Addendum 42 – Regulation No. 43

Revision 3 - Amendment 4

Supplement 4 to the 01 series of amendments – Date of entry into force: 8 October 2015

Uniform provisions concerning the approval of safety glazing materials and their installation on vehicles

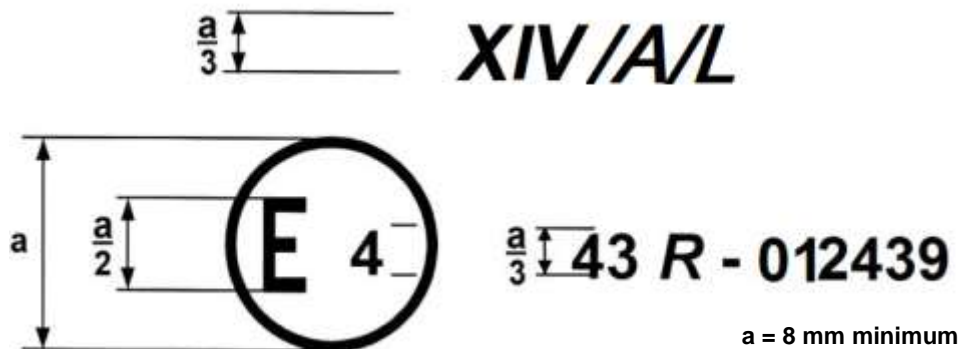
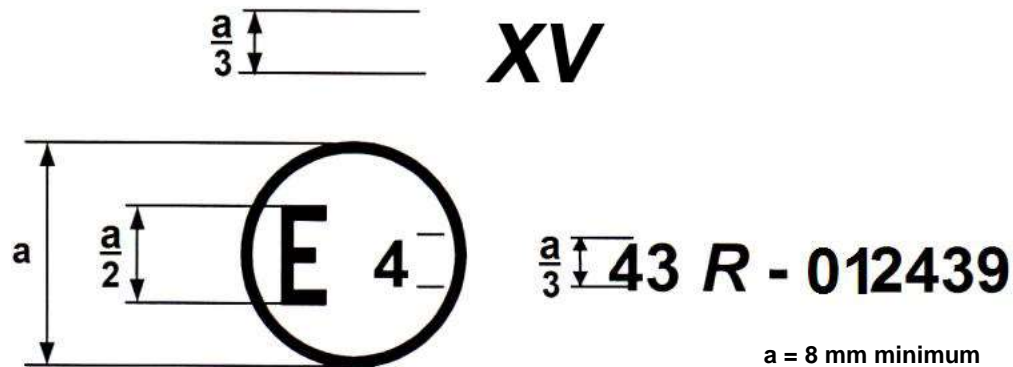
Add at the end of the annex the following new paragraphs:

The above approval mark affixed to a rigid plastic windscreen shows that the component concerned has been approved in the Netherlands (E 4) pursuant to Regulation No. 43 under approval No. 012439. The approval number indicates that the approval was granted in accordance with the requirements of Regulation No. 43, as amended by the 01 series of amendments.

The above approval mark affixed to a laminated rigid plastic glazing pane for forward facing panels with a light scatter not exceeding 2 per cent after 1,000 cycles (in case of Taber test) on the outer surface and 4 per cent after 100 cycles on the inner surface shows that the component concerned has been approved in the Netherlands (E 4) pursuant to Regulation No. 43 under approval No. 012439. The approval number indicates that the approval was granted in accordance with the requirements of Regulation No. 43, as amended by the 01 series of amendments.

Figure 6
 Sand drop equipment

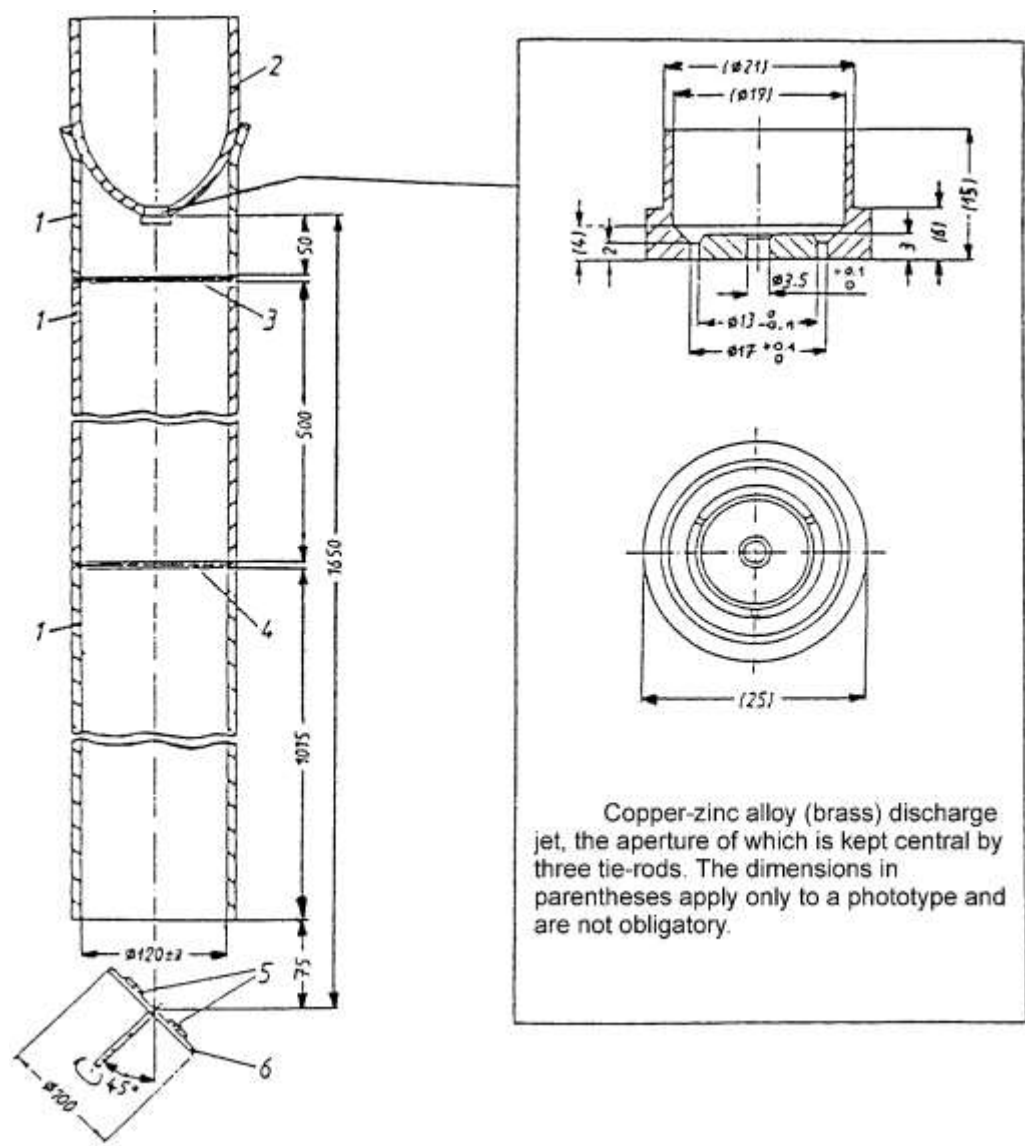
Insert a new paragraph 4.7. (including a new Figure 6), to read:

The sand drop test equipment shall consist essentially of that illustrated in Figure 6. The gravity tube consists of three separate rigid polyvinylchloride tubes (PVC hard) of the same diameter, with two polyamide sieves mounted in between. The sieves should have a mesh size of 1.6 mm. The speed of the turntable shall be 250 ± 10 rev/min.

- 4.7.2. Abrasive material
Natural quartz sand of grain size of 0.50/0.70 mm, with no oversize, obtained by sieving on wire sieves complying with ISO 565 with a mesh size of 0.50 mm and 0.70 mm. The sand may be used up to 10 times.

- 4.7.3. Test pieces
Three square flat pieces 50 mm x 50 mm of each type shall be taken from the flattest part of the windscreen in the area specified in paragraph 2.2. of Annex 21 (test area A). The test shall be carried out on the face corresponding to the outside of the windscreen.
The test piece shall be conditioned to (23 ± 2) °C and (50 ± 5) per cent relative humidity (rH) for minimum 48 hours and subjected to testing at ambient temperature.

- 4.7.4. Test procedure
Three kilograms of 0.50/0.70 mm grain size quartz sand shall drop through a gravity tube from a height of 1,650 mm onto the sample to be tested. The test piece and, if necessary, a control-piece shall be mounted on a turntable, the axis of which is a 45° angle to the direction of the sand.
The test pieces shall be mounted on the turntable in such a way that the area to be measured does not extend beyond the turntable. One cycle of 3 kg sand drop shall be performed while the turntable is rotating.
The surface of the test piece shall be washed in water containing 1 per cent detergent and rinsed with distilled or demineralized water, then carefully dried with a grease-free and dust-free linen cloth.
Immediately after drying and before abrasion, the initial haze shall be measured according to Annex 3, paragraph 4.4.3. of this Regulation, and the haze shall be measured again immediately after abrasion. A haze meter, according to Annex 3, paragraphs 4.1.3. to 4.1.5. of this Regulation, shall be used for measuring the haze."

Figure 7

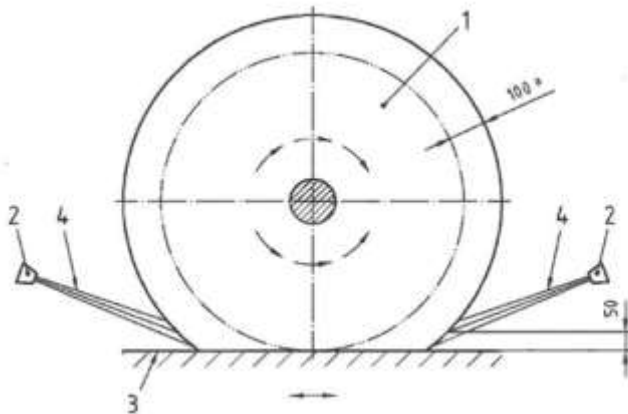
Insert a new paragraph 4.8. (including new Figures 7 to 10), to read:

Penetration depth (100 ± 20) mm (see Figure 7)

Figure 8
Calibration arrangement

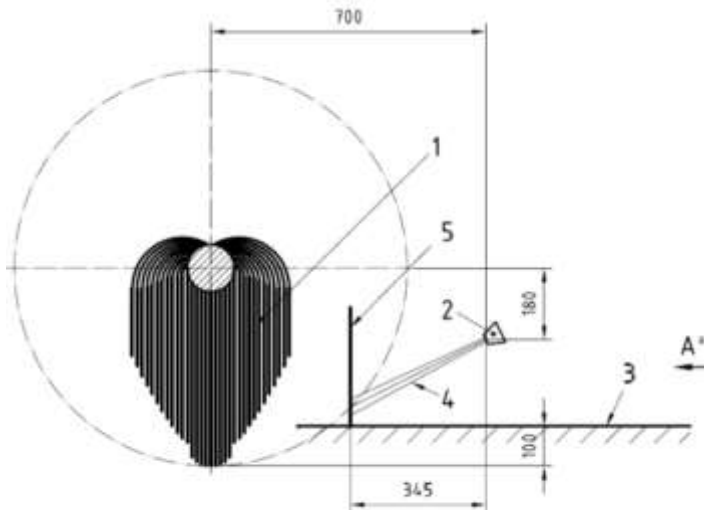
4.8.4.1.3. Do the instrument calibration as follows: Set up the equipment as shown in Figure 8. Fill with washing suspension (see paragraph 4.8.2. of this annex and wet the brush sufficiently. Determine the flow rate of the water, (2.2 ± 0.1) l/min., by measurement and adjust by altering the pressure, (300 ± 50) kPa. Check the spray pattern of the nozzles (see Figure 9) If the spray pattern cannot be achieved or if the pressure regulation exceeds the tolerances, check, and if necessary replace, the nozzles.

Figure 10

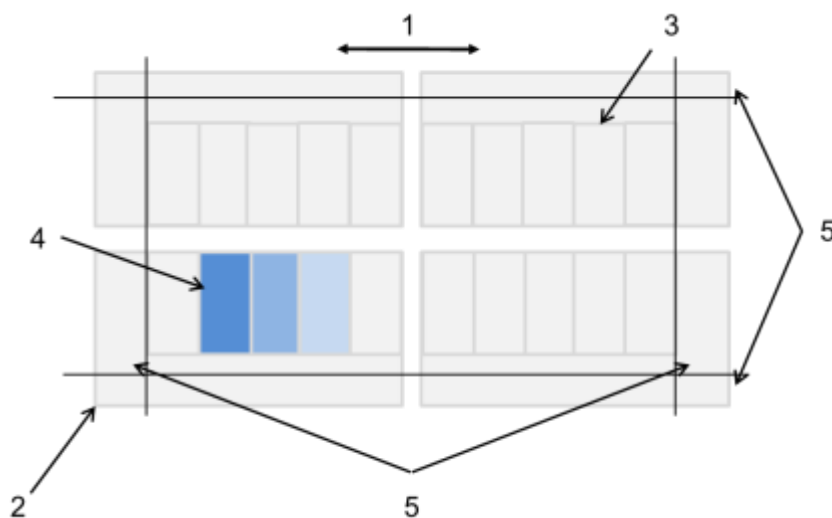
4.8.4.2.1. Affix the samples with the outside surface face up onto a supporting plate by using a double-faced adhesive tape (Sample positioning on the test holder as shown in Figure 10).

Figure 11

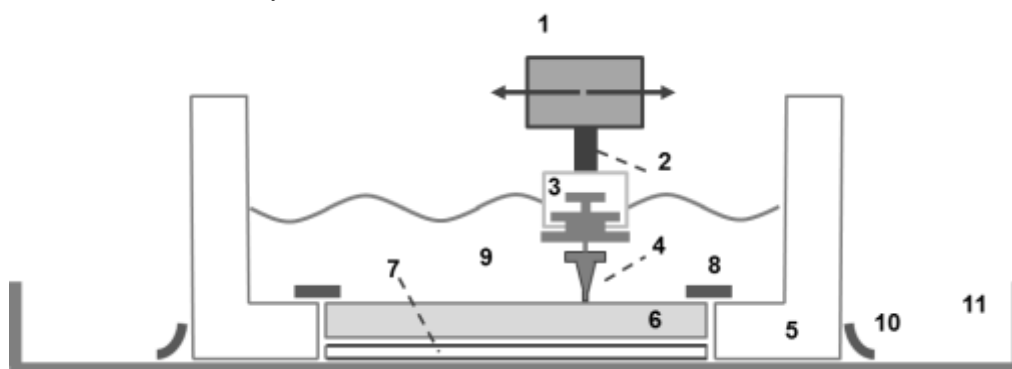
Insert a new paragraph 4.9. (including new Figures 11 to 16), to read:

- 4.9.1.2. A wiper carriage assembly (see 1 in Figures 11 and 12) having a beam which spans across the width of the base apparatus and can be mounted at its ends to the pillars, furthermore this carriage assembly has two self-supporting arms (see 2 in Figures 11 and 12) where a wiper holder can be attached (the distance between the sample surface and bearing of self-supporting arm at the carriage assembly is 100 to 105 mm),

- 4.9.1.3. A wiper holder² (see 3 in Figure 11) suitable to attach a normal wiper blade (see 4 in Figure 11) and adjusted to provide a load of 15 ± 0.5 g/cm (the weight of the wiper blade and its holder together with the wiper blade width determine the wiper load in g/cm),

- 4.9.1.4. Two sample boxes³ (see 5 in Figures 11 and 12) made out of inert, material in the interior dimension of 200 mm x 120 mm (50 mm height) used to be filled with the aqueous suspension and having a hole at the bottom⁴ where the test sample can be inserted and therefore used as a test sample holder,

- 4.9.1.5. Different spacer plaques (see 7 in Figure 11) (e.g. made out of the sample box material) in the dimension of the sample but with different thicknesses used to compensate different test sample thicknesses (it is necessary that the bottom surface of the sample box and the sample surface to be tested are on the same height); furthermore care has to be taken to avoid scratching the test sample placed on top of the spacer (e.g. by placing an ultrathin soft film on the surface of the spacer),
- 4.9.1.6. A stainless steel tray (see 11 in Figures 11 and 12),
- 4.9.1.7. A wipe cycle counter.

Figure 13
Cross profile of the chloroprene type rubber blade

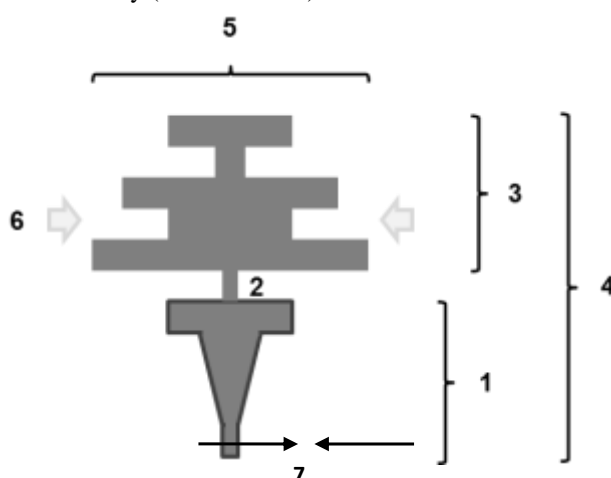
⁶ A suitable wiper blade can be e.g. Bosch "H-Stoff P6.3" with a cross profile as shown in Figure 13, or its successor "H-Stoff P32" or equivalent. A complete description of the blade, including its hardness value, its mechanical properties and the composition and thickness of its coating shall be added to the test report.

Figure 14

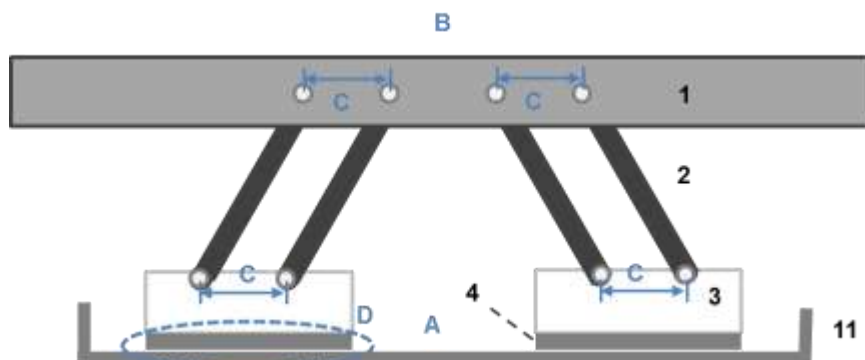
4.9.5.2.2. Build up the whole instrument including tray, wiper carriage assembly, wiper blade holders and new wiper blades but without sample box and sample (see Figure 14). To do so the two new wiper blades shall be mounted to their respective wiper blade holders and the latter ones shall be fixed to the carriage assembly. Then align using a spirit level the base plate where later the sample box will be placed and the wiper carriage assembly. Check that the distances of the two bearings of both self-supporting arms at the wiper carriage assembly and at the wiper blade holder are identical. Furthermore control visually that the wiper blade rest on the base plate uniformly without losing contact to the base plate at any point of the wiper blade.

- A Align base plate with spirit level
- B Align wiper carriage assembly with spirit level
- C Check that the bearings of the self-supporting arms have all the same distance
- D Control visually that the wiper blade touches the base plate uniformly

Figure 15

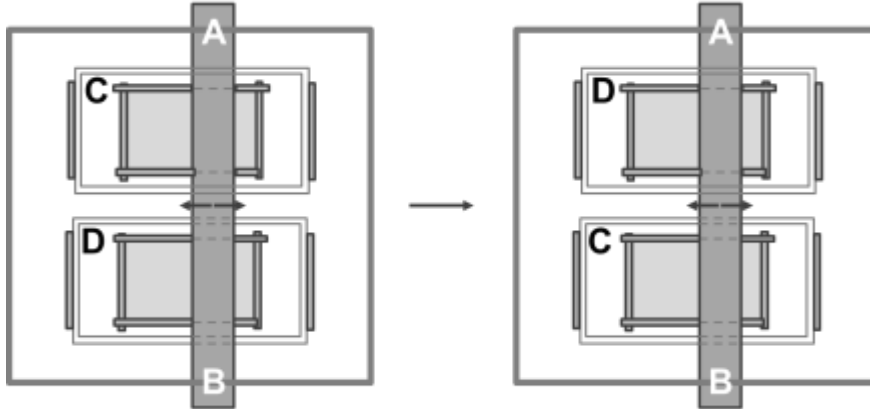
- 4.9.5.3.6.1. After half of the test cycle numbers 10,000 cycles the test shall be stopped and the two sample boxes shall be exchanged without turning them (see Figure 15);¹⁰ this leads to an exchange for the two simultaneously tested samples regarding their wiper blades and furthermore alters the alignment of the self-supporting arm carrying the blade (from left to right or the other way round).

Figure 16

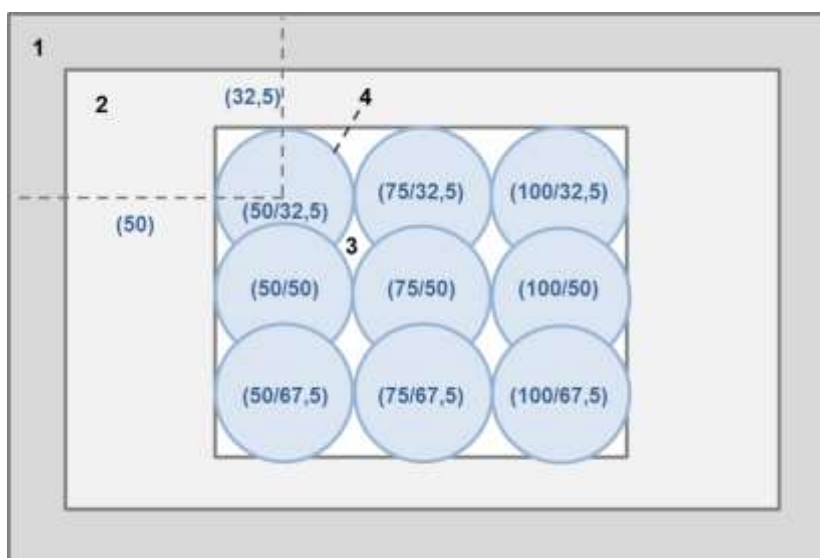
The initial haze value according to Annex 3, paragraph 4.4.3. of this Regulation of the test sample is measured at 9 measurement points across the sample (see 4 in Figure 16).

- 4.9.5.4.4. Nine measurement points according to Figure 16 below shall be used to determine the delta haze at these points and calculate an average delta haze afterwards.

Design drawing of the wiper blade holder

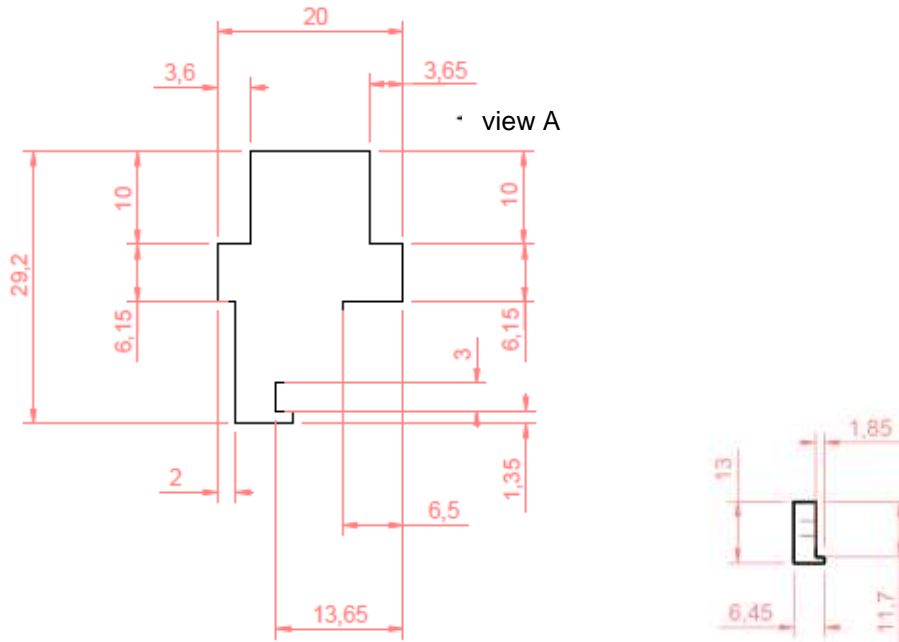
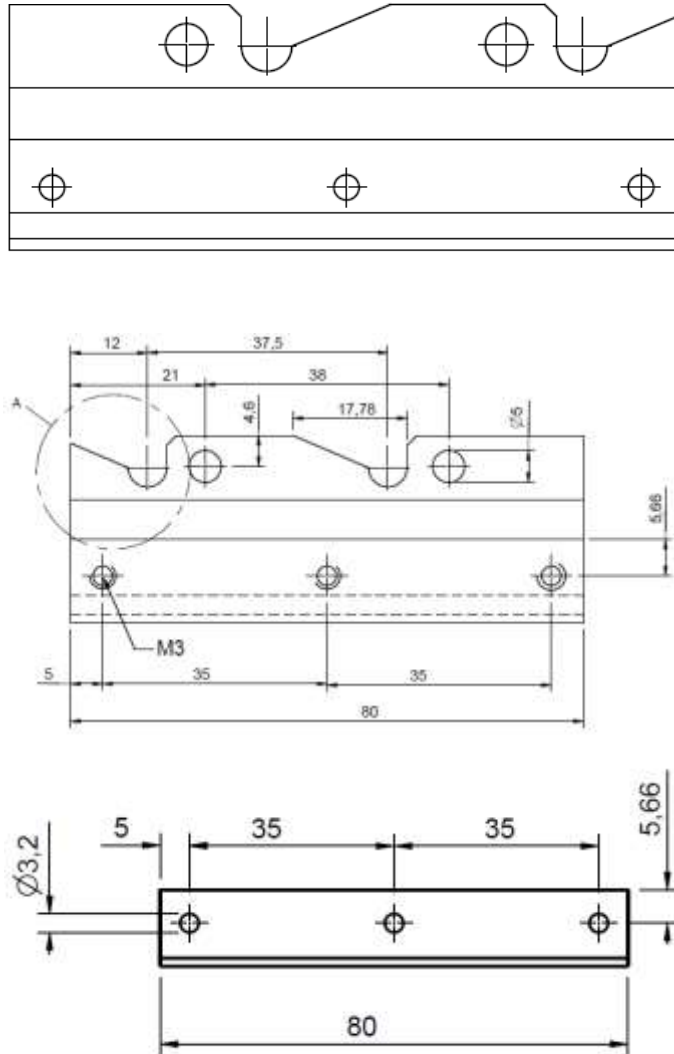
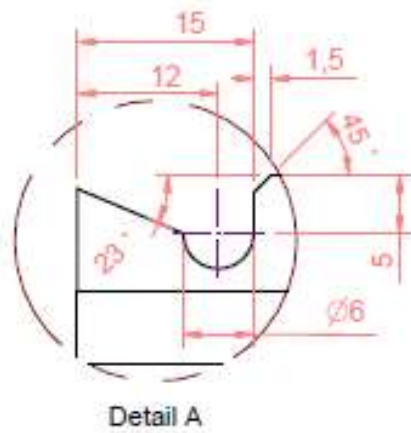
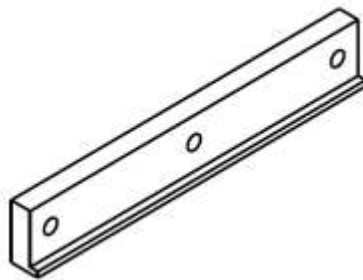
² For a design drawing see Appendix 1.

Insert new Appendices 1 and 2, to read:

Design drawing from the sample box

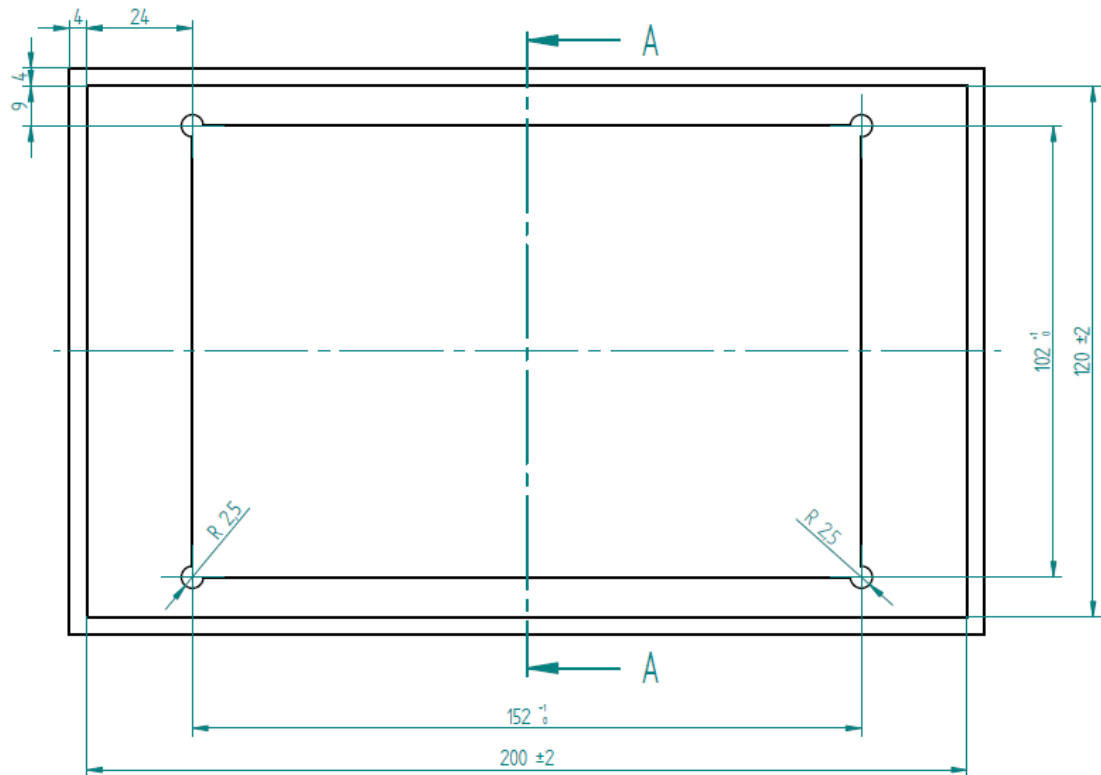
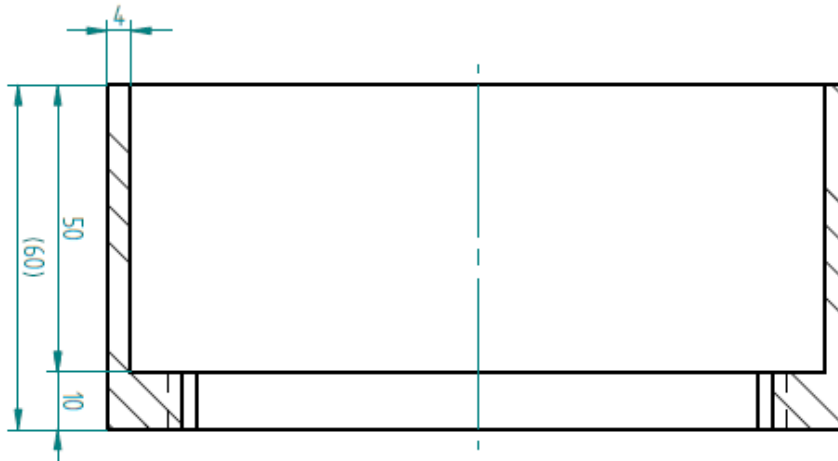
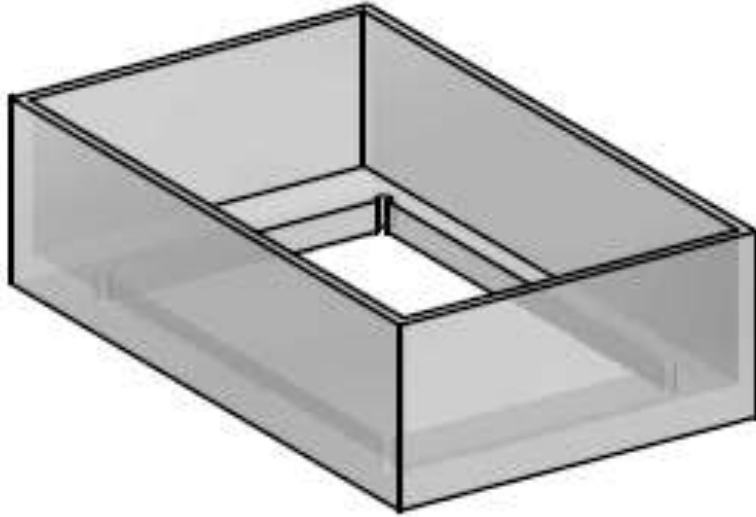
³ For a design drawing see Appendix 2.
